To: T10 Technical Committee  
From: Timothy Hogle, LSI Logic  
Date: 28 February 2006  
Subject: Serial Attached SCSI - 2 (SAS-2)

Revision 0 (28 February 2006) first revision

This proposal seeks to remove link layer race conditions present within the SAS-1.1 specification, namely the potential for BREAKs to cross on the wire with either OPEN\_REJECTs or CLOSEs leading to potential livelock scenarios involving Open and Break Timeouts.

Figure 1 — BREAK crossing OPEN\_REJECT

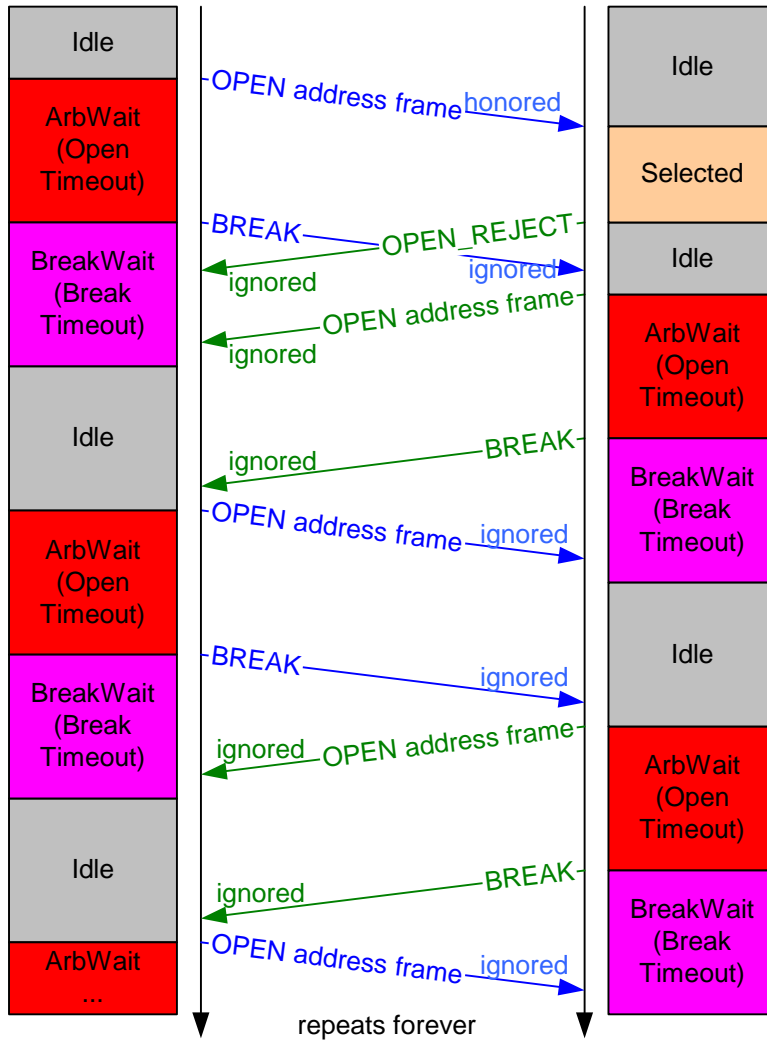
Figure 1 below (from proposal T10/05-086r0) demonstrates the potential of BREAK and OPEN\_REJECT crossing leading to two phys ping-ponging OPENs and BREAKs forever.

Figure 2 — BREAK crossing OPEN\_REJECT

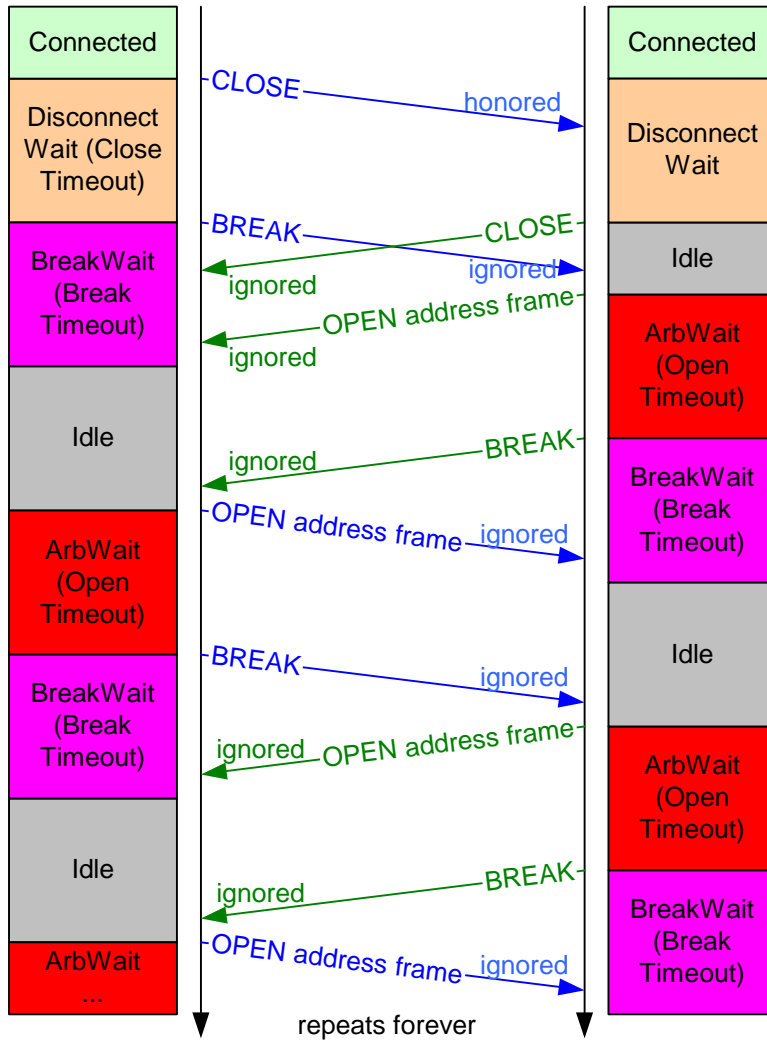
Figure 2 below (from proposal T10/05-086r0) demonstrates the potential of BREAK and OPEN\_REJECT crossing leading to two phys ping-ponging OPENs and BREAKs forever.

Figure 141 — Aborting a connection request with BREAK

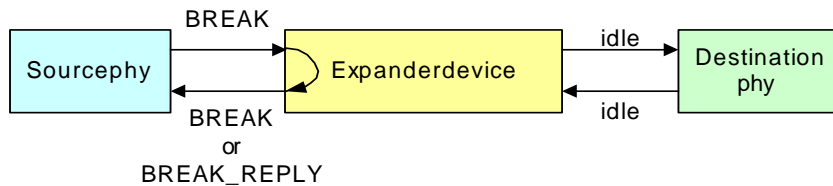
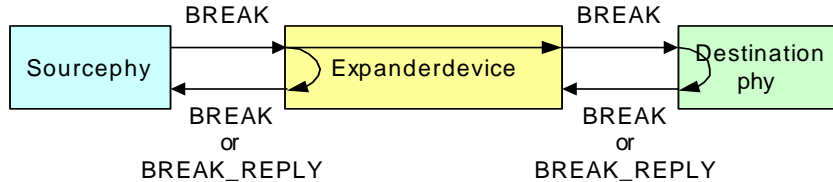
When a phy sourcing a BREAK is attached to an expander device, the BREAK or BREAK\_REPLY (see 7.8.2) response to the source phy is generated by the expander phy to which the source phy is attached, not the other SAS phy in the connection. If the expander device has transmitted a connection request to the destination, it shall also transmit BREAK to the destination. If the expander device has not transmitted a connection request to the destination, it shall not transmit BREAK to the destination. After transmitting BREAK or BREAK\_REPLY (see 7.8.2) back to the originating phy, the expander device shall ensure that an open response does not occur (i.e., the expander device shall not forward dwords from the destination any more). Figure 141 shows an example of BREAK usage.

Figure 146 — SL (link layer for SAS phys) state machines (part 2)

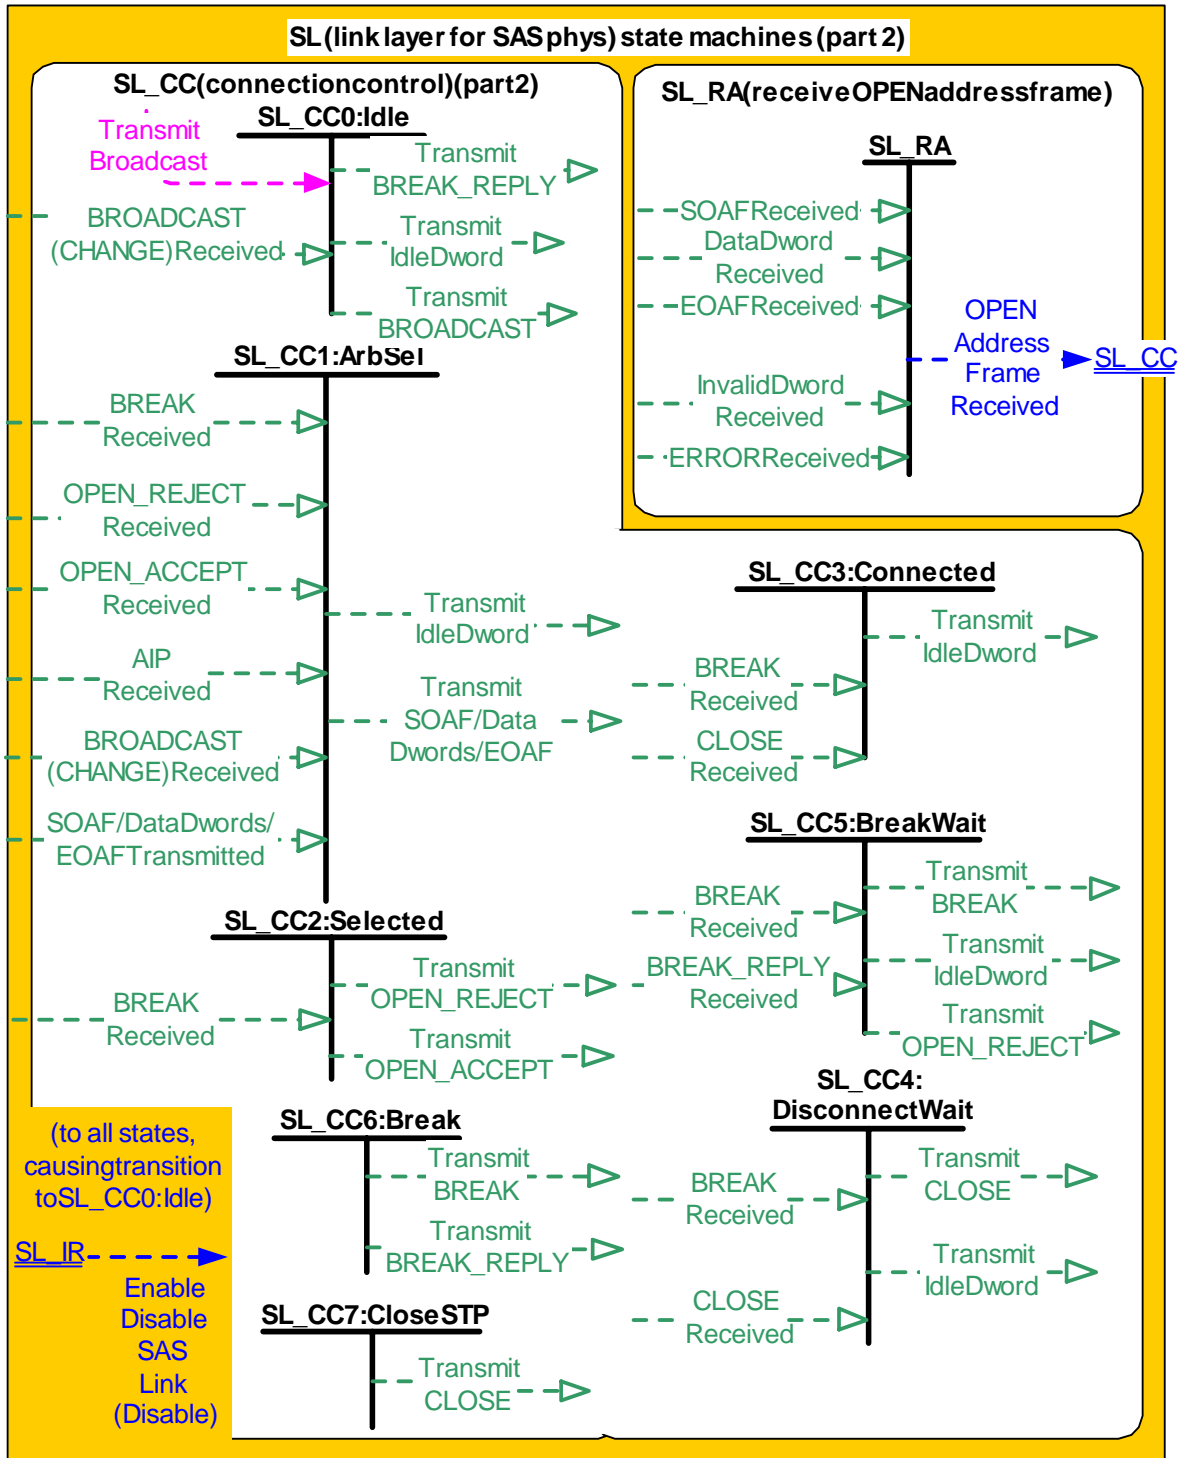
Figure 146 shows the messages sent to the SL transmitter and received from the SL receiver.

Figure 147 — XL (link layer for expander phys) state machine (part 1)

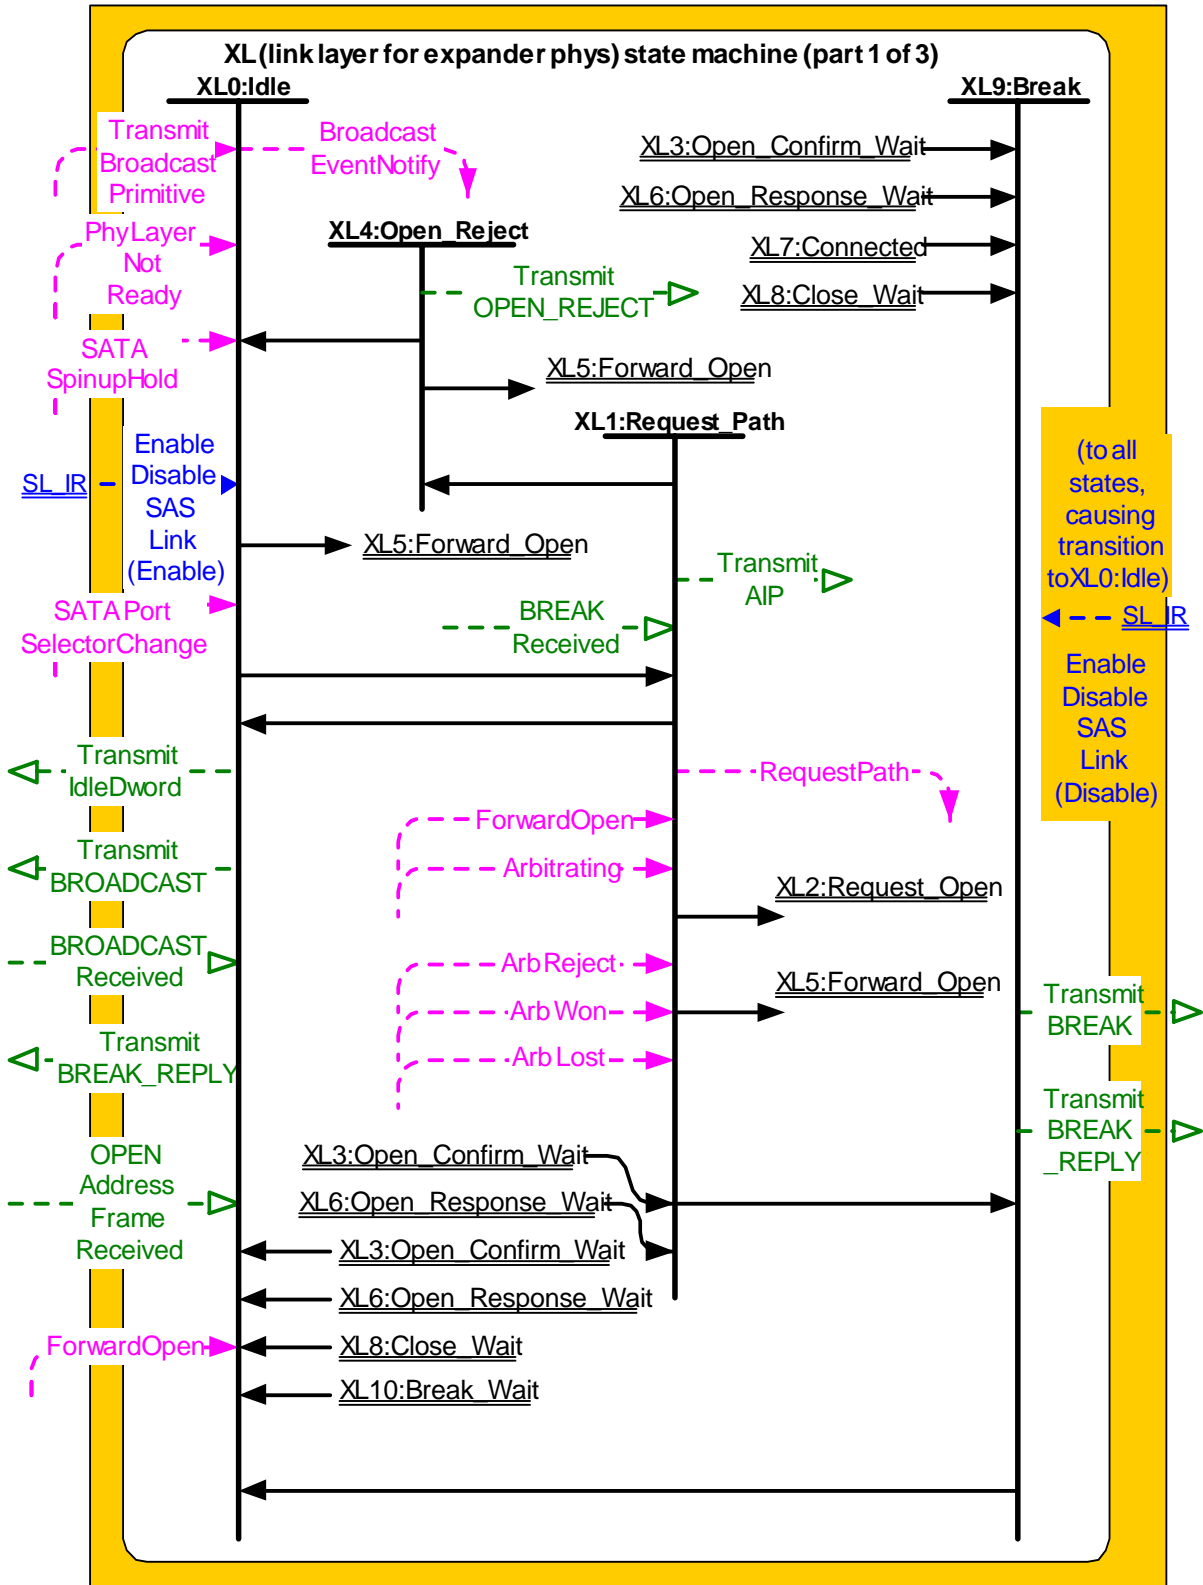
Figure 147 shows several states in the XL state machine.

Figure 148 — XL (link layer for expander phys) state machine (part 2)

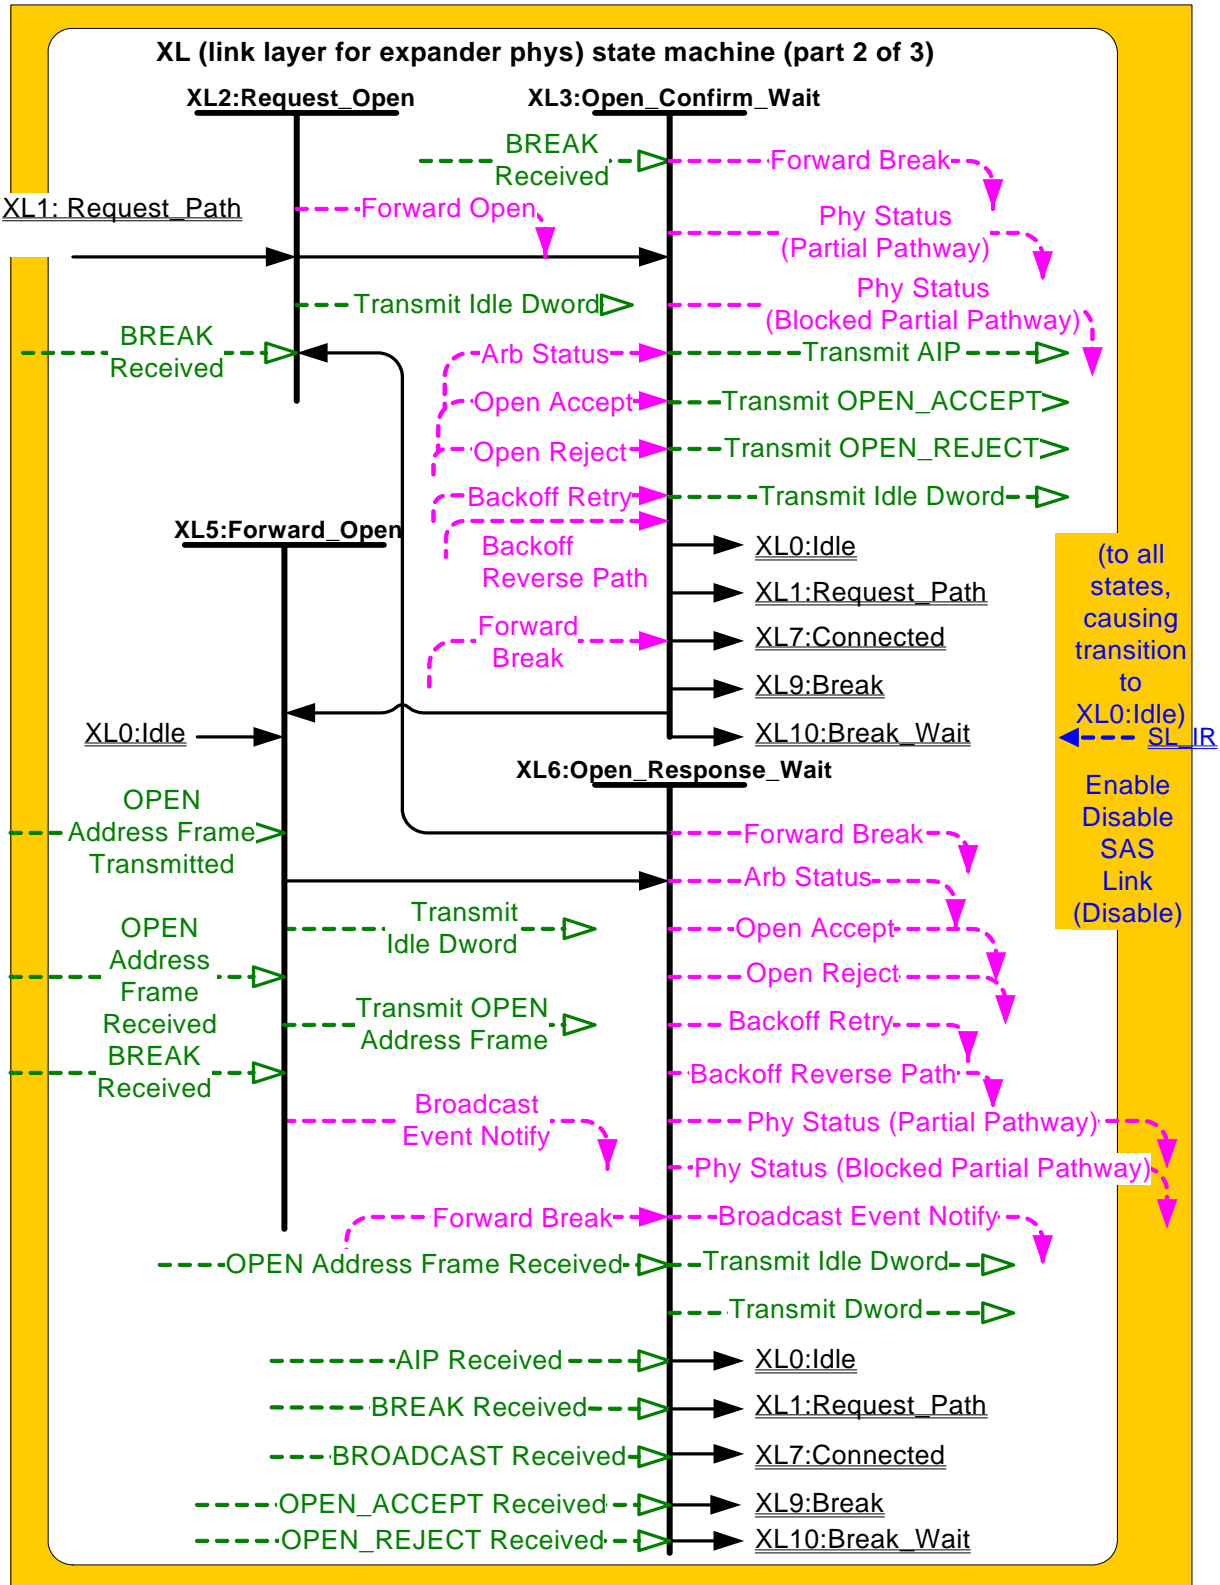
Figure 148 shows additional states in the XL state machine.

Figure 149 — XL (link layer for expander phys) state machine (part 3)

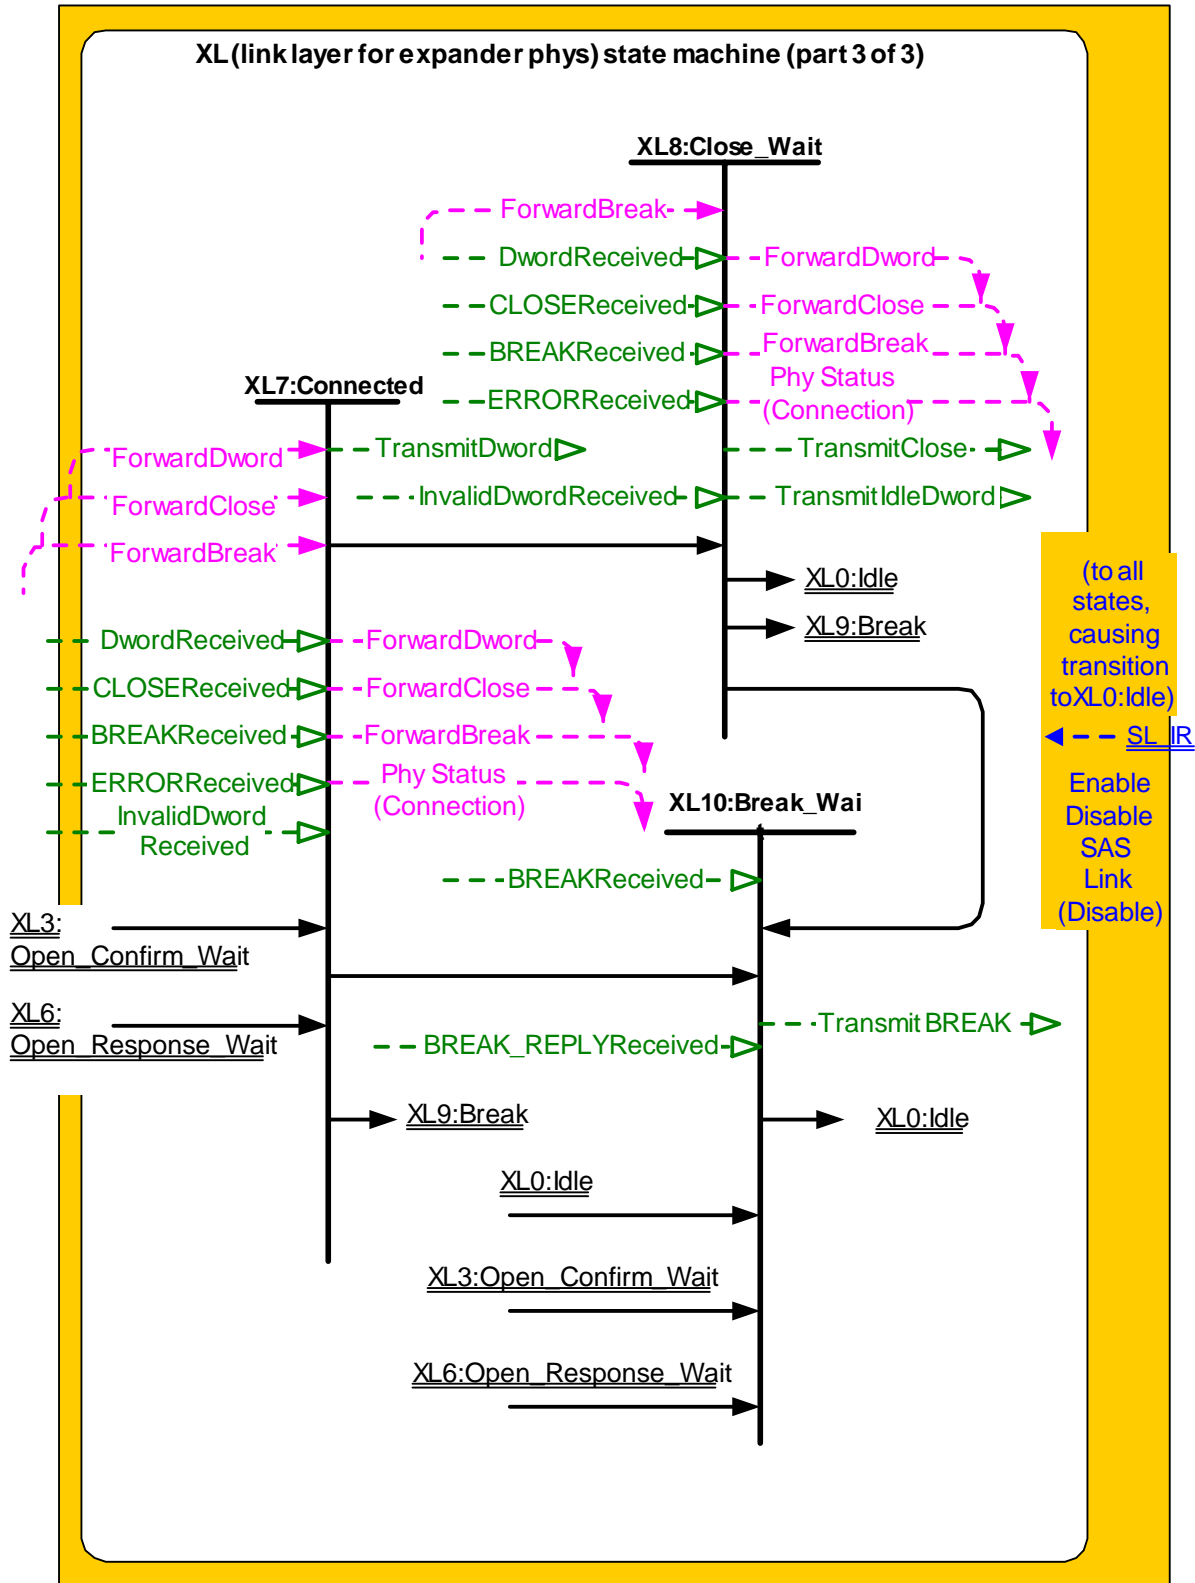
Figure 149 shows additional states in the XL state machine.
